# ADDENDUM NO. 2 TO THE

# GARDENDALE AND VILLAGE PARK WEST PRESSURE REDUCING STATION (PRS) REPLACEMENT PROJECT June 19, 2024

PRS FOUNDATION
PLAN AND SECTION

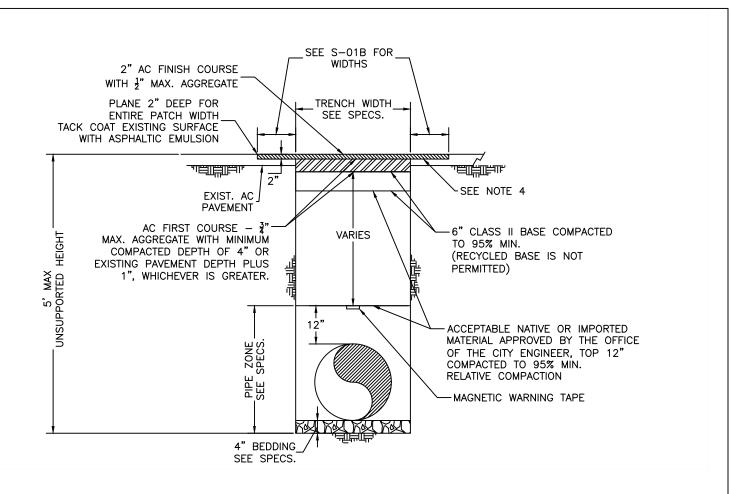
- 7. Village Park West Location How long will the sewer agency allow ground water to be disposed of into the sewer system.
  - A: Release of accumulated water into the sanitary sewer system will be limited to 3 weeks, unless otherwise approved in writing by the Owner and Sewer Agency. To limit the duration of the excavation, the PRS subgrade and backfill have been modified to accelerate the installation. See REVISED Drawing S-2.

1. Drawing S-2 PRS Foundation Plan & Section; **REVISE** per attached Drawing

- 2. IN CONFORMANCE WITH THE GEOTECHNICAL ENGINEER'S RECOMMENDATIONS, PLACE A MINIMUM OF 24 INCHES OF CRUSHED 3/4" ROCK BELOW FOUNDATION. PLACE TENSAR INTERAX NX650 REINFORCING GEOGRID WITHIN CRUSHED ROCK LAYER WITH A MINIMUM OF 6 INCHES OF CRUSHED ROCK BENEATH THE GEOGRID.

- 7. PROVIDE 6,000 PSI CEMENT SLURRY WITH POLAR SET OR SIMILAR FOR EARLY STRENGTH.
